# Refat Garments Ltd (Extension 2)

144,147,148 Narashingpur, Ashulia, Savar, Dhaka.

20 February 2024

### Observation-02: Absence of concrete compressive strength test result. (Chemical Store)

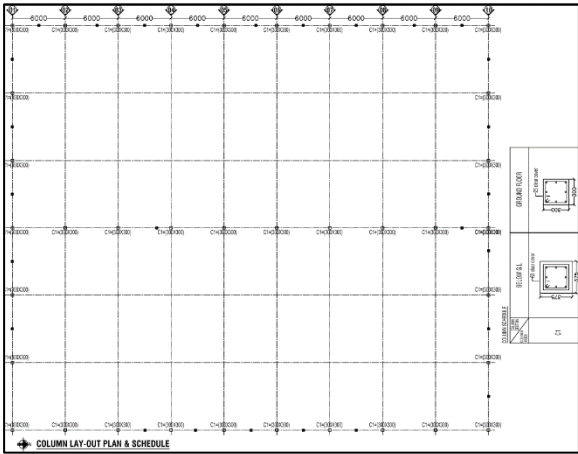
**Description:** In the design report, the compressive strength of concrete was considered as 3500 psi for column, footing, beam & slab etc. However, no concrete compressive strength test result was available onsite. The building engineer is required to verify in-situ material strength by taking a minimum adequate number of concrete cores and review the analysis & design report.

| Observation  | Action Plan   | Timeline        |
|--|---|-----------------|
| Absence of concrete compressive strength test result. (Chemical Store)                           | Verify in situ concrete strength (100mm dia. cores from 4 columns) from the lower tier of the building.                                       | within 6 weeks  |
|  | The building engineer is required to revise the design report for the concrete strength and submit it to RSC for review.                      | within 6 weeks  |

**Observation-05:** Adequacy of gantry girder, corbel and columns for overhead crane need to be checked (ETP Large).

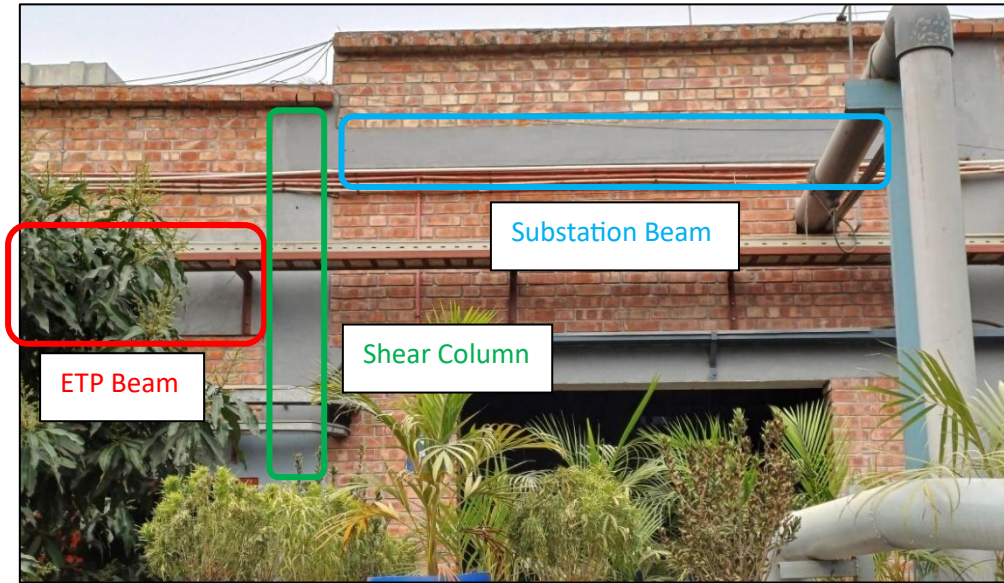
**Description:** In the design report, no adequacy check of gantry girder, corbel and columns for overhead crane have been found. The building engineer is required to incorporate the adequacy check of gantry girder, corbel and columns for overhead crane in design report.

| Observation  | Action Plan   | Timeline        |
|--|---|-----------------|
| Adequacy of gantry girder, corbel and columns for overhead crane need to be checked (ETP Large). | The building engineer is required to incorporate the adequacy check of gantry girder, corbel and columns for overhead crane in design report. | within 6 weeks  |

**Observation-9: Inconsistency in the design documents (Utility & Storage Building).**

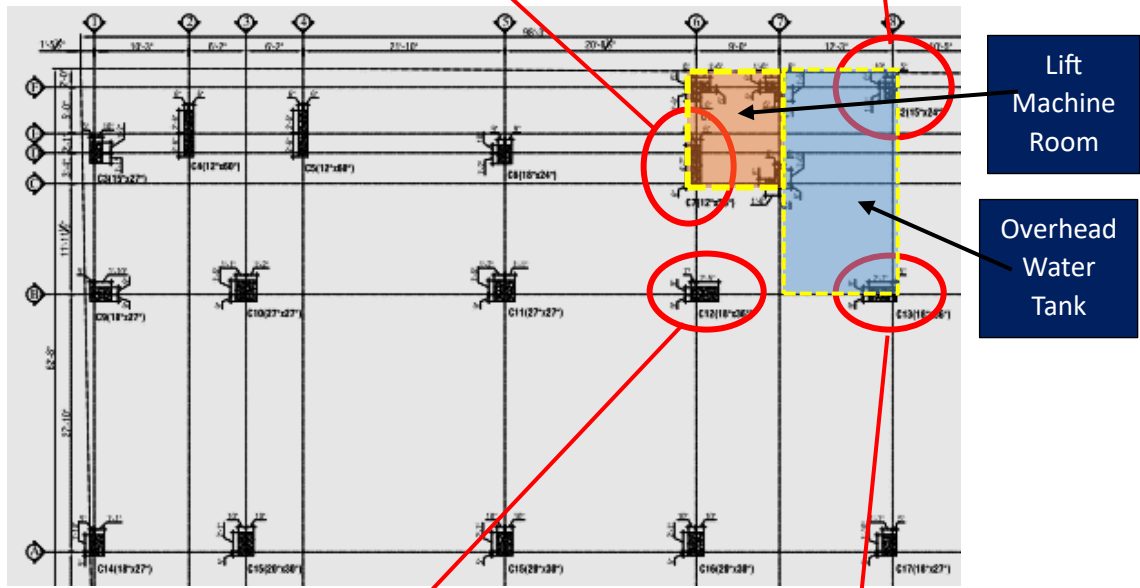
Column size reduced above roof level  
12'X56" to 12" X24"

Column size reduced above the roof  
15'X24" to 15' X18"

Column size reduced above the roof  
18'X36" to 18" X18"

Column size reduced above the roof  
18'X36" to 18" X18"

100 mm thick build-up at 1<sup>st</sup> floor is not shown in the drawing or not incorporated in the design report

**Description:** The size of 4 columns below the lift machine room and overhead water tank has been reduced from the roof level. 100 mm thick buildup was found on the 1st floor which was not incorporated in as-built drawing & design report. Mismatch found in concrete compressive strength between as-built drawing and design report (For column: 4500 psi in design report but 4000 psi in drawing, for beam & slab: 3500 psi in design report but 3000 psi in drawing). Live load was mentioned in the design report but no load plan was available during inspection.

The building engineer is required to revise the as-built drawing as per onsite condition, produce the load plan as per BNBC minimum requirement, update the design report as per the revised as-built drawing and load plan and submit all documents to RSC for review.

| Inconsistency in the design documents (Utility & Storage Building)         | The building engineer is required to survey the full structure and produce accurate as-built drawings.   | within 6 weeks  |
|  | The building engineer is required to revise the EA report for as-built condition based on in-situ material strength and submit the EA to RSC for review. | within 6 weeks  |

Footing Layout (Construction Drawing)

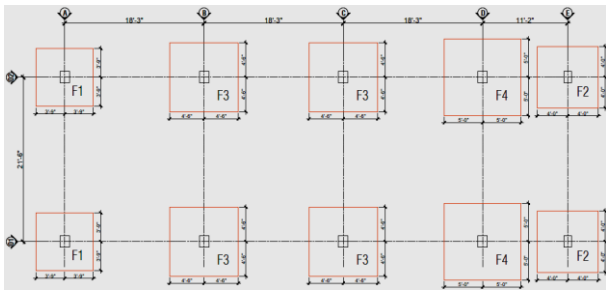
**Description:** During the inspection, mismatches (some snapshots were provided above) were found in all structural elements (foundation, column, beam, slab etc.) between construction drawing and as-built drawing. The building engineer is required to survey the whole structure & update the as-built drawing as per onsite condition.

| Inconsistency between construction drawing and as-built drawing (Substation & Generator Building). | The building engineer is required to survey the whole structure & update the as-built drawing as per onsite condition.                              | within 6 weeks  |
